SOUTHWEST INTERTIE PROJECT

FINAL ENVIRONMENTAL IMPACT STATEMENT and PROPOSED PLAN AMENDMENT

July 1993

CORRECTIONS TO: Panel 2 - Alternative Routes

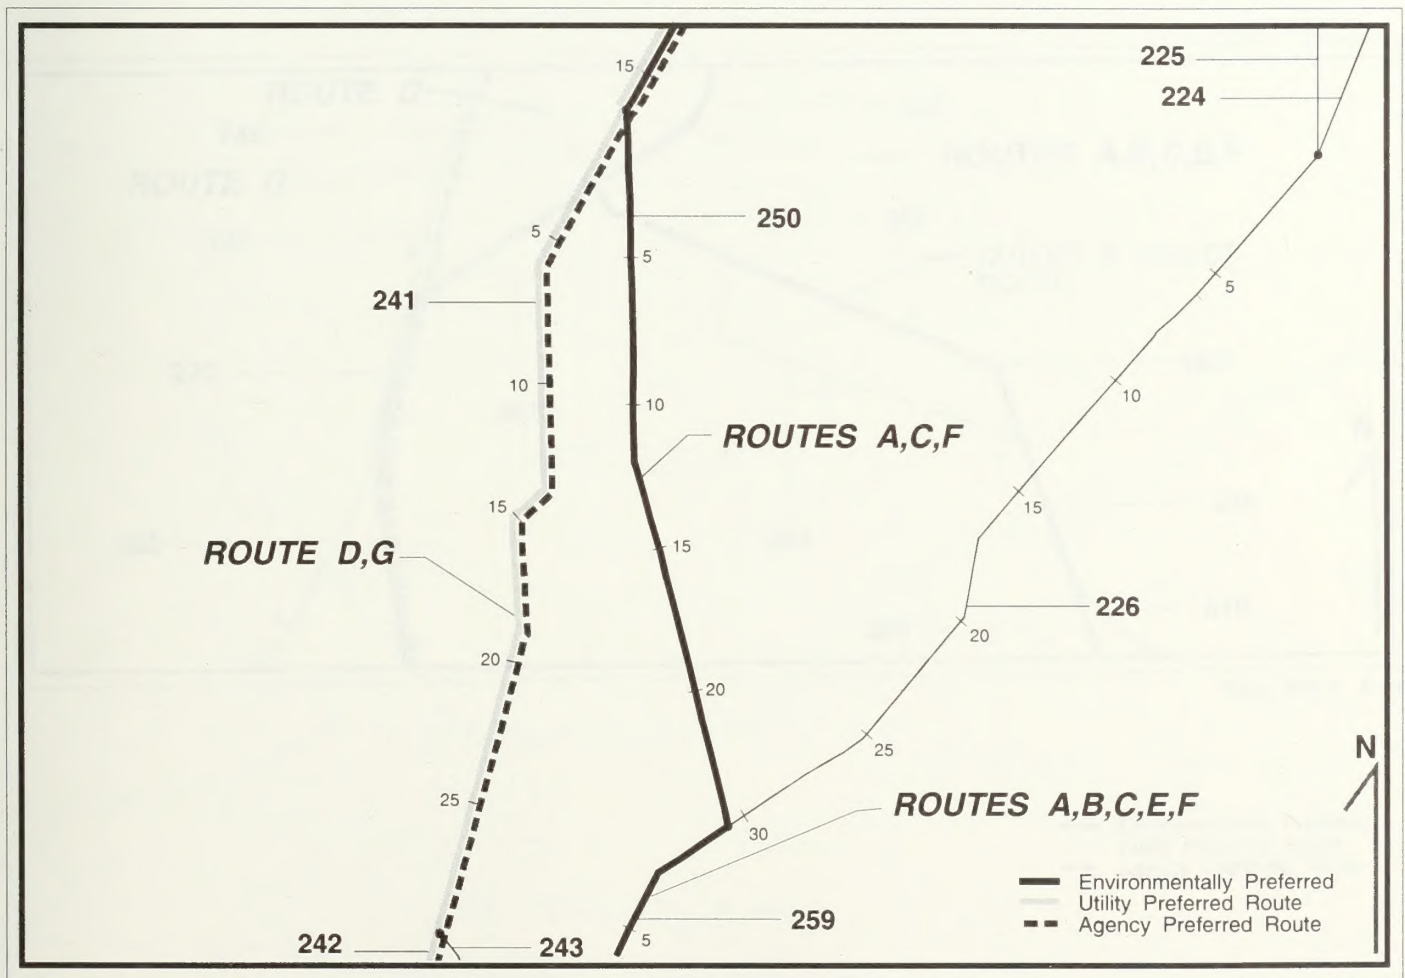
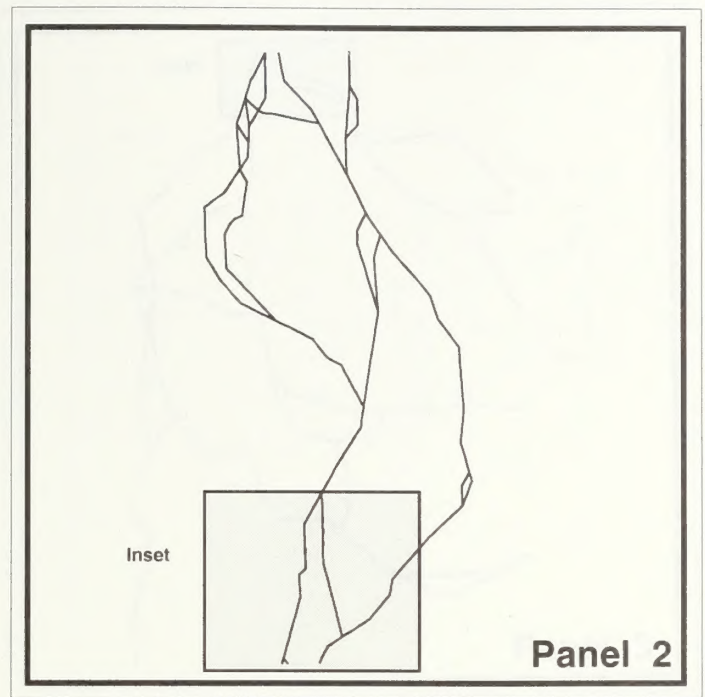
Panel 2 - Alternative Routes Map: Route D was incorrectly labeled on this map. The map shows Route D following Links 250, 259, and 260. Route D should actually follow Links 241, 243, and 245. Figure 4-1 indicates the corrected labeling of the alternative routes.

The labels for Route D were incorrect on this map. The correct labeling for Route D is shown below.

CORRECTIONS TO: Panel 3 - Alternative Routes

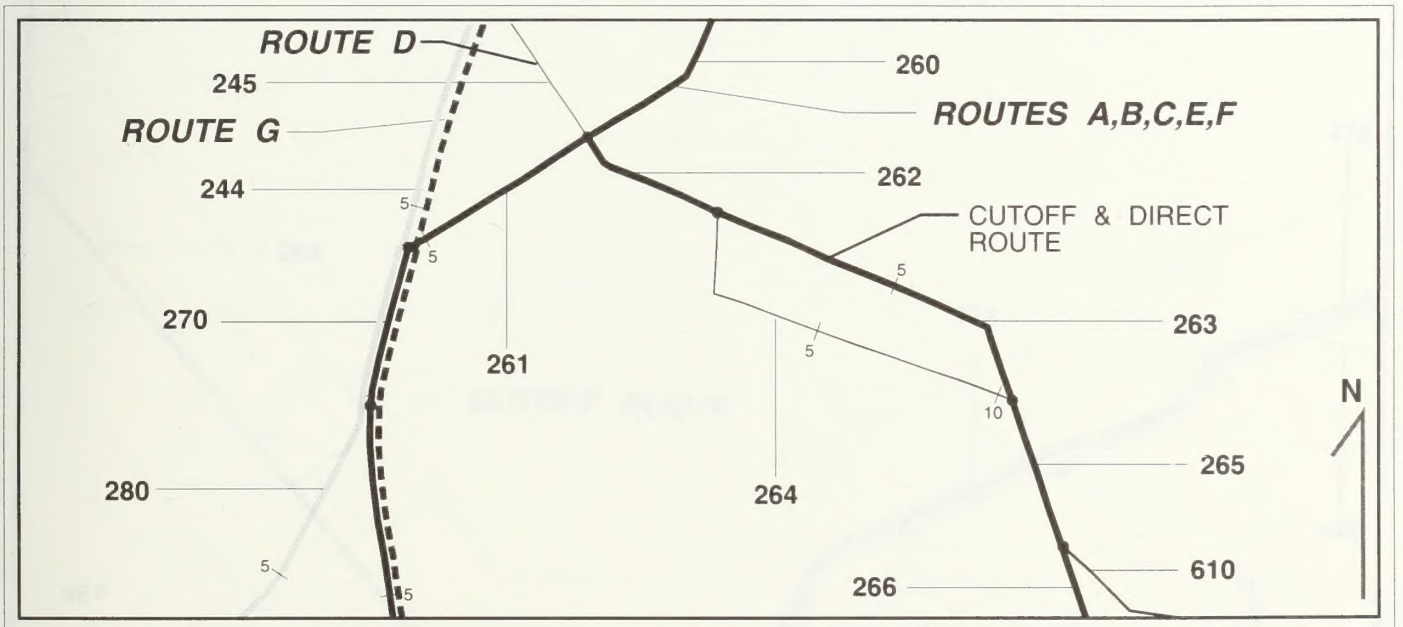
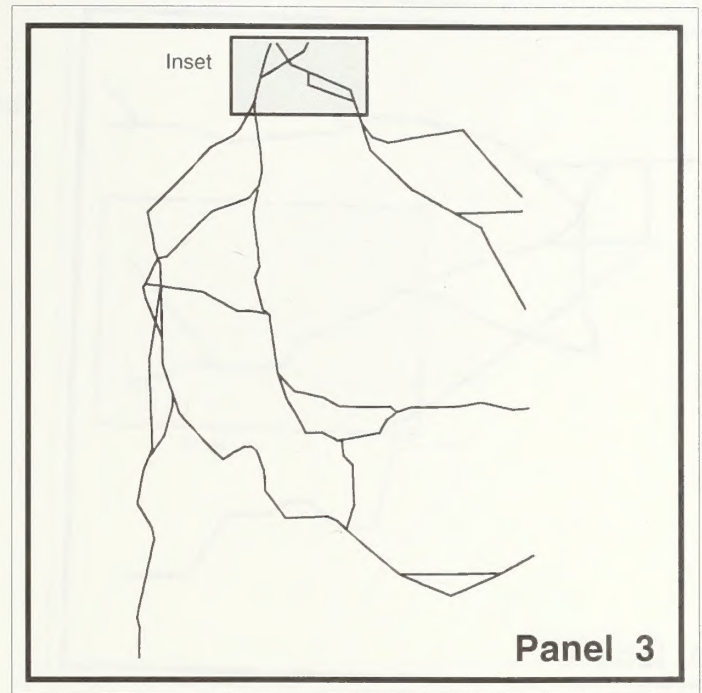
Panel 3 - Alternative Routes Map: Route D was incorrectly labeled on this map. The map shows Route D following Links 250, 259, and 260. Route D should actually follow Links 241, 243, and 245. Figure 4-2 indicates the corrected labeling of the alternative routes.

The labels for Route D were incorrect on this map. The correct labeling for the Route D is illustrated below.

CORRECTIONS TO: Panel 4 - Alternative Routes

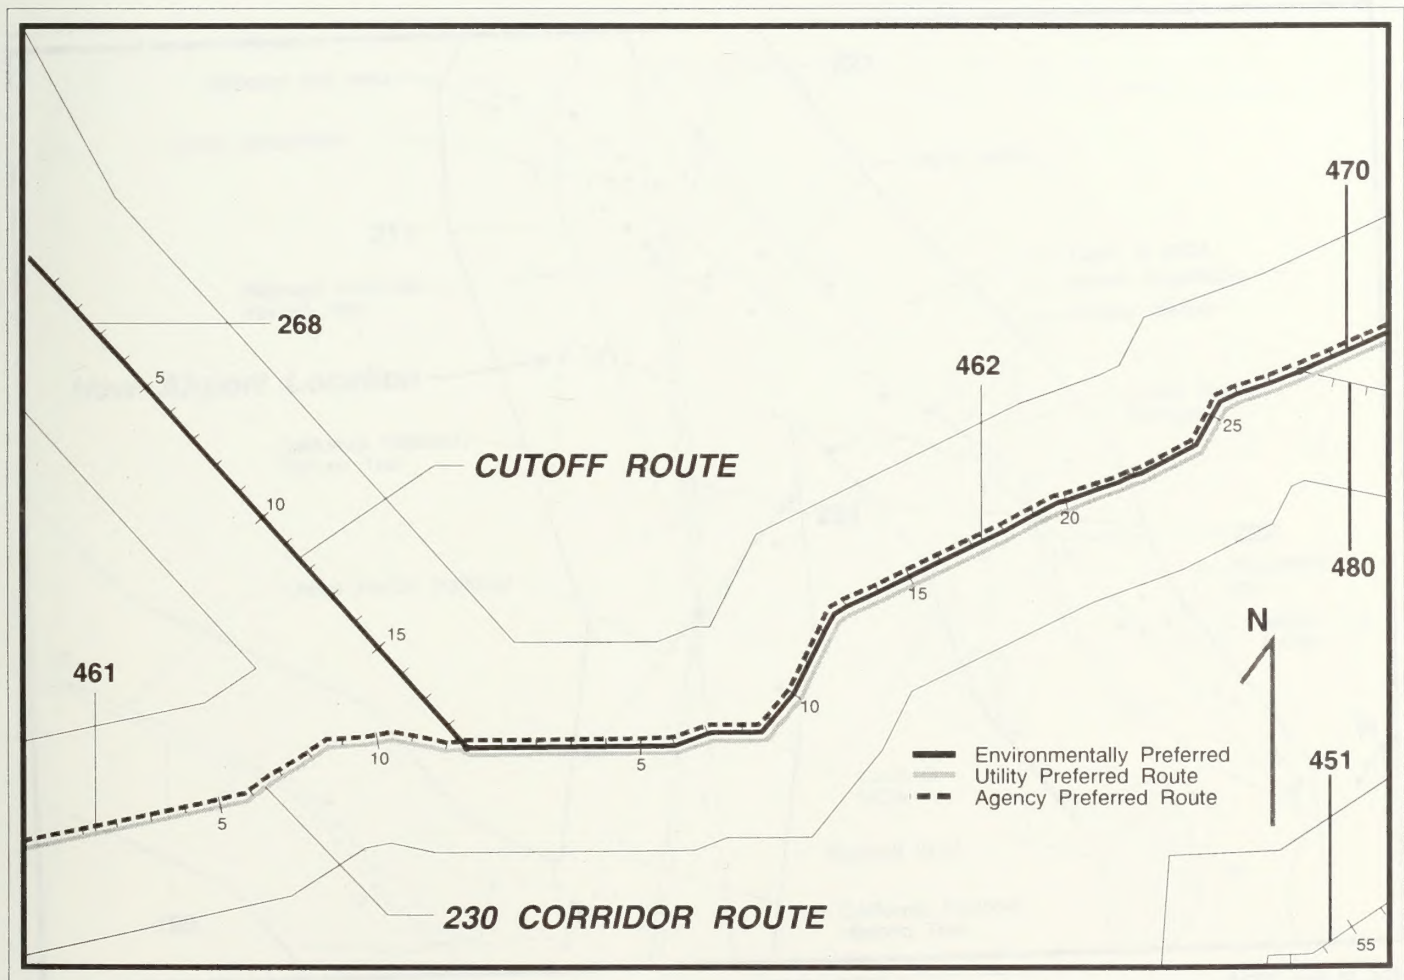
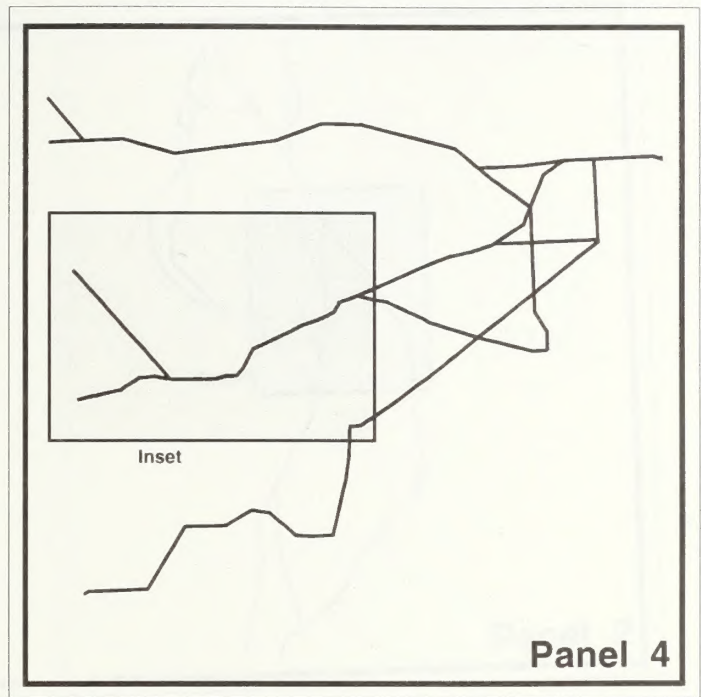
Panel 4 - Alternative Routes Map: The labels for the "230kV Corridor Route" and "Cutoff Route" are transposed on this map. Figure 4-3 indicates the corrected labeling of these alternative routes.

The labels for "230 kV Corridor Route" and "Cutoff Route" were transposed on this map. The correct labeling is illustrated below.

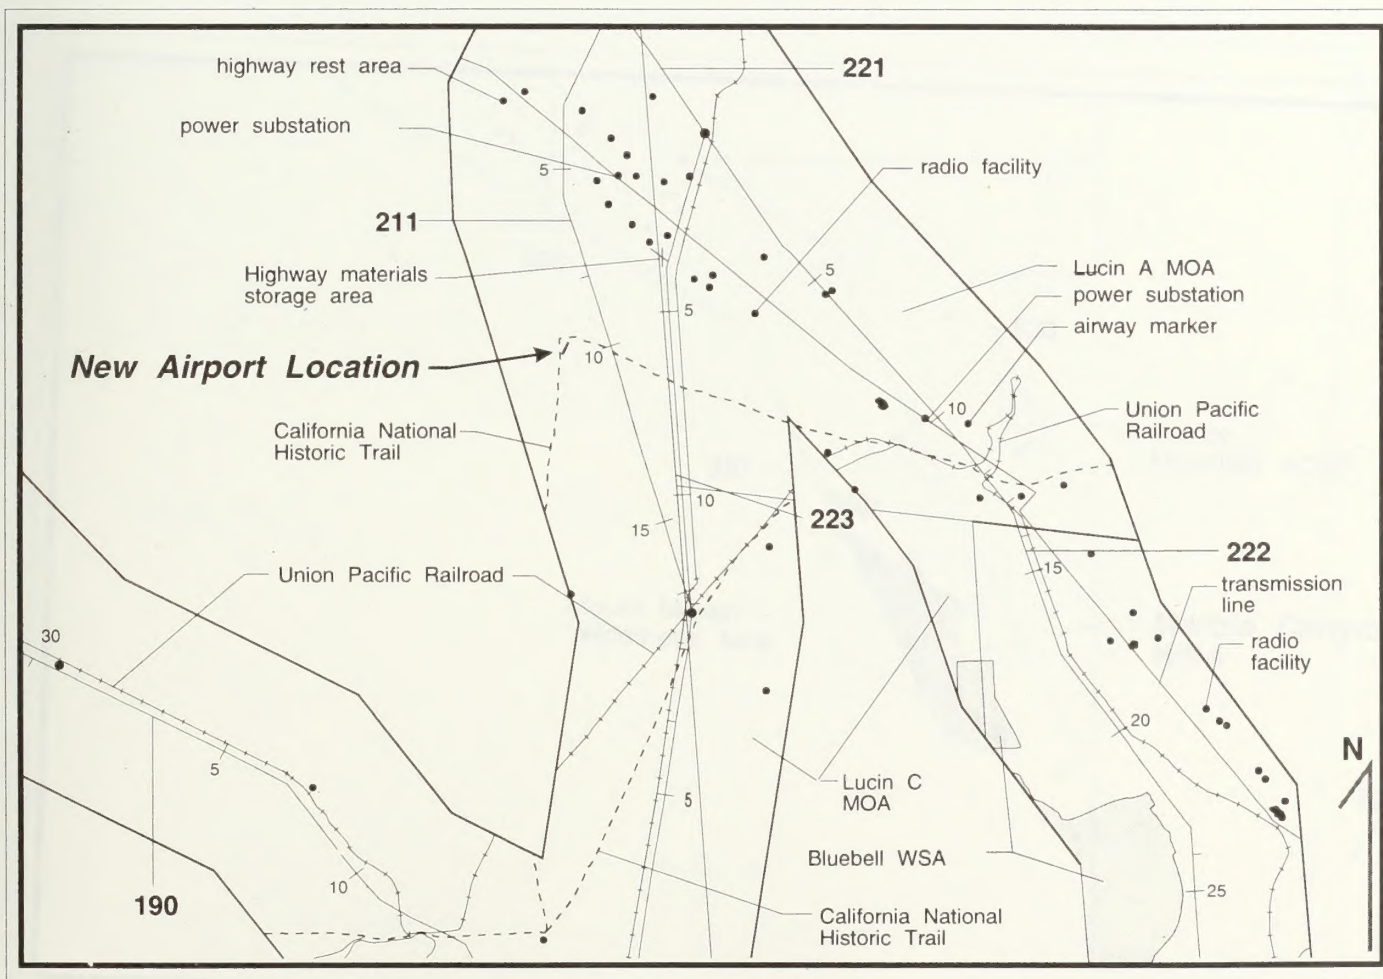
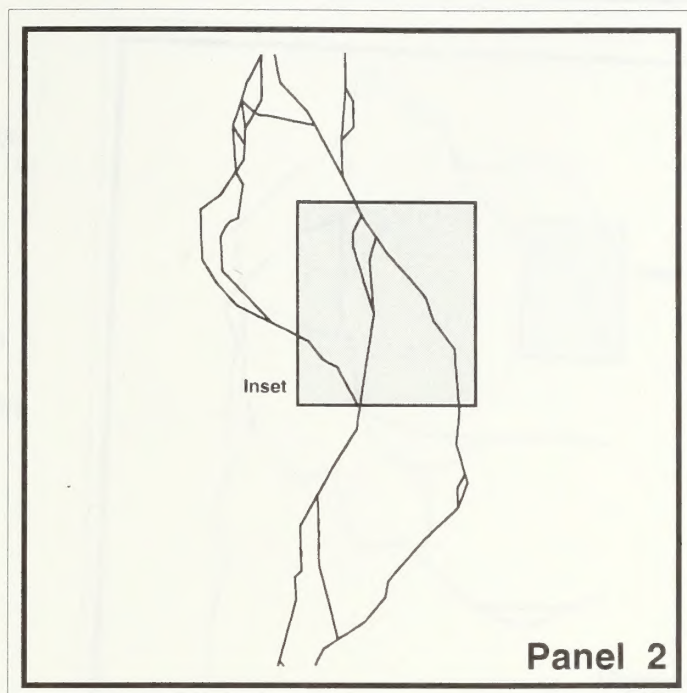
Panel 2 - Land Use Resources: The Big Springs Ranch private grass airstrip is missing from this map. Figure 4-4 indicates the location of the airstrip.

A private grass airstrip near Big Springs Ranch was not shown on this map. Its location is illustrated below.

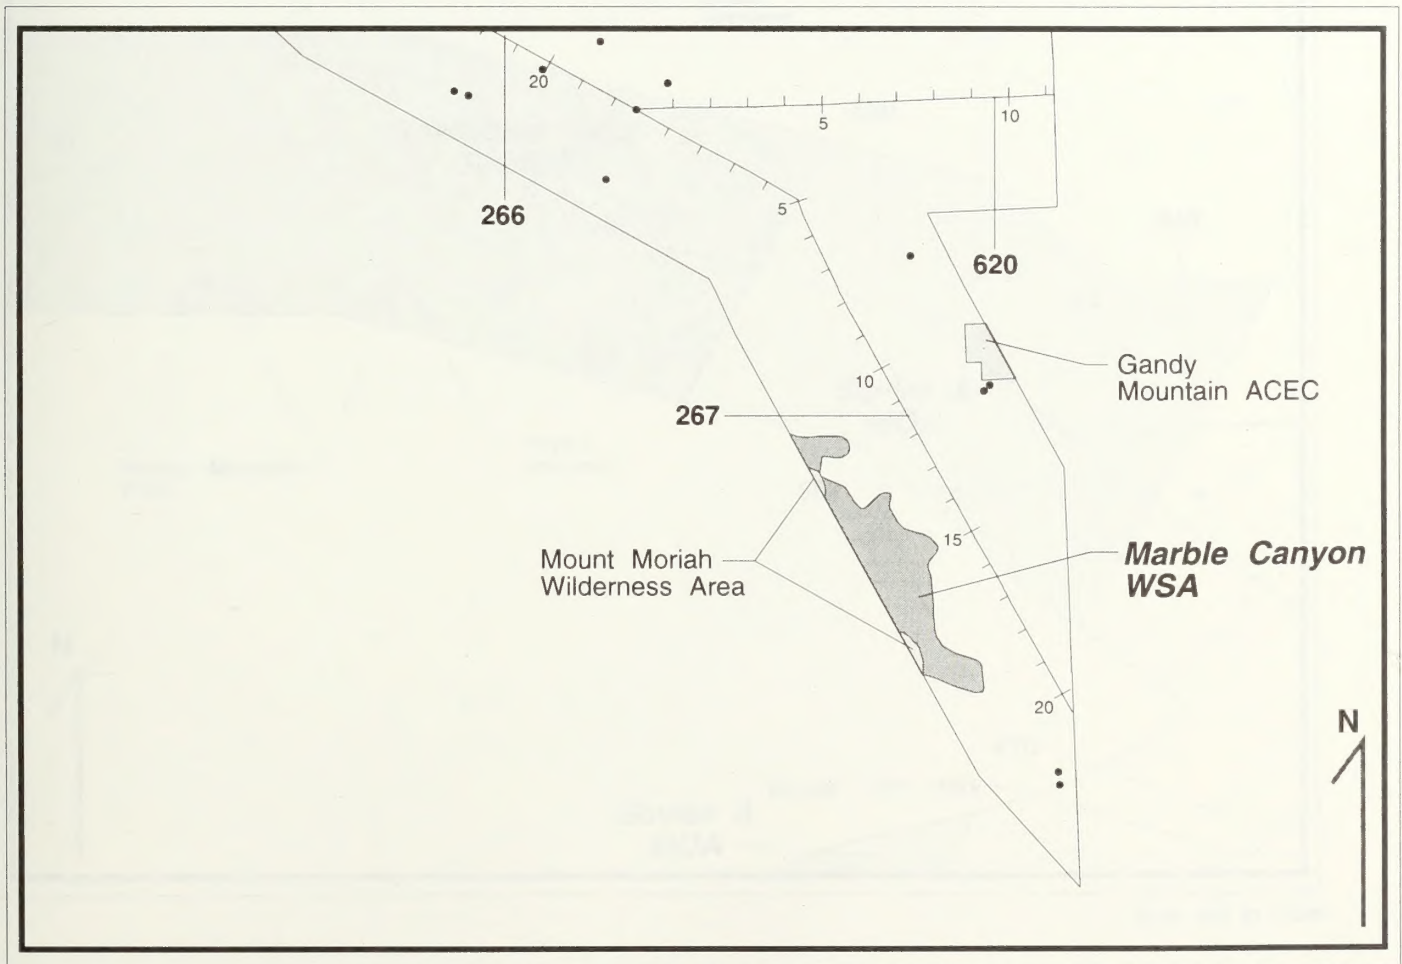
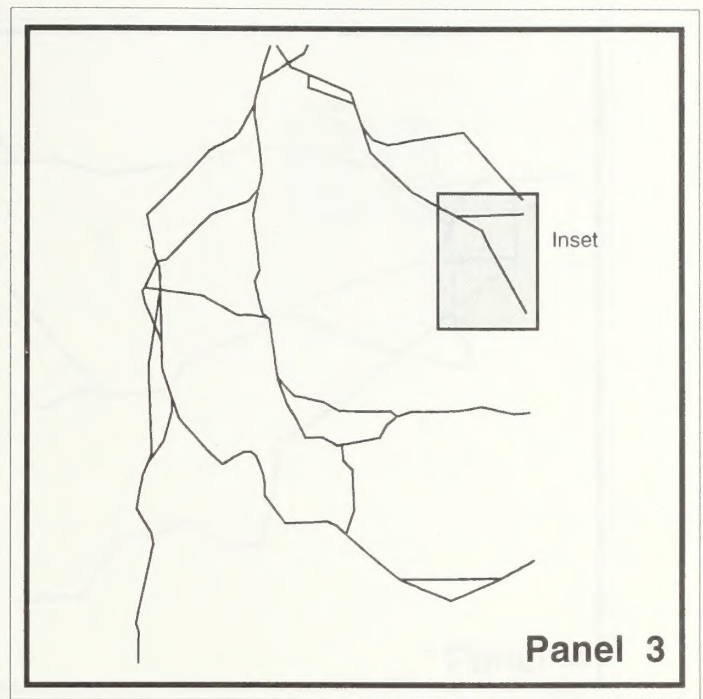
Panel 3 - Land Use Resources: Marble Canyon WSA is not shown on this map. It is located on Link 267 and illustrated in Figure 4-5.

Marble Canyon WSA was not shown on this map. The boundary for this area is illustrated below.

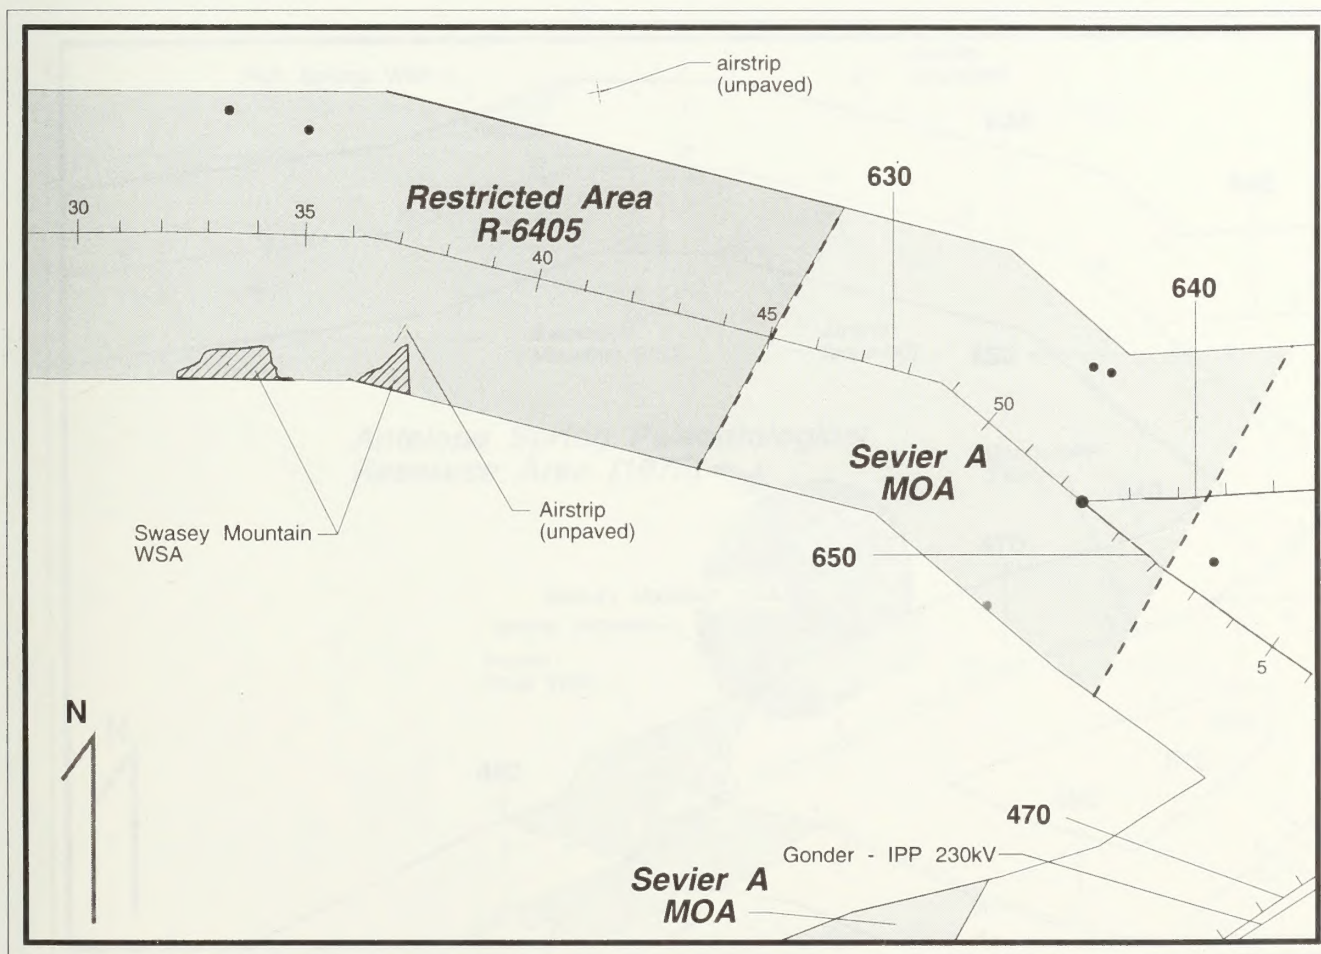
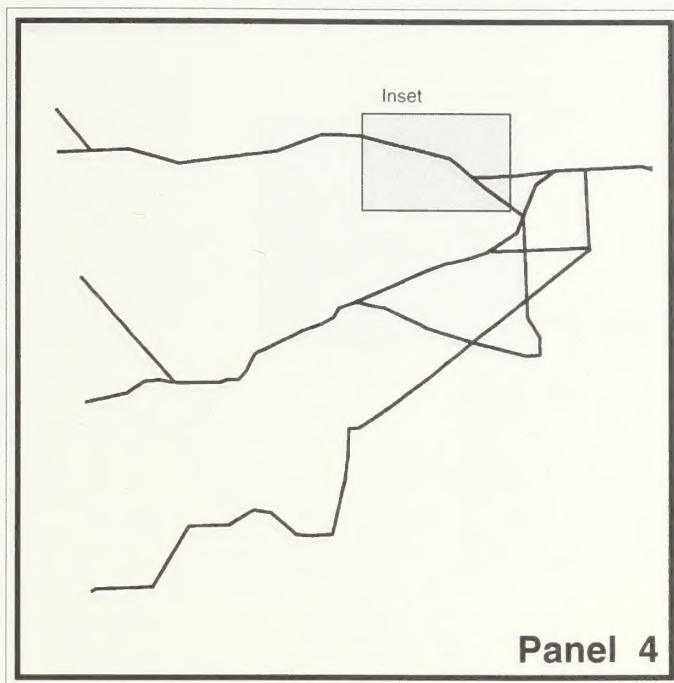
Panel 4 - Land Use Resources: The R-6405 Restricted Area is mapped incorrectly. Figure 4-6 shows the corrected boundary and labeling. The proposed Antelope Spring Trilobite Beds was not mapped. The location of the Antelope Spring Trilobite Beds is illustrated in Figure 4-7.

The Restricted Area R-6405 was mapped incorrectly on the Panel 4 - Land Use Resources Map. It is illustrated in the below diagram.
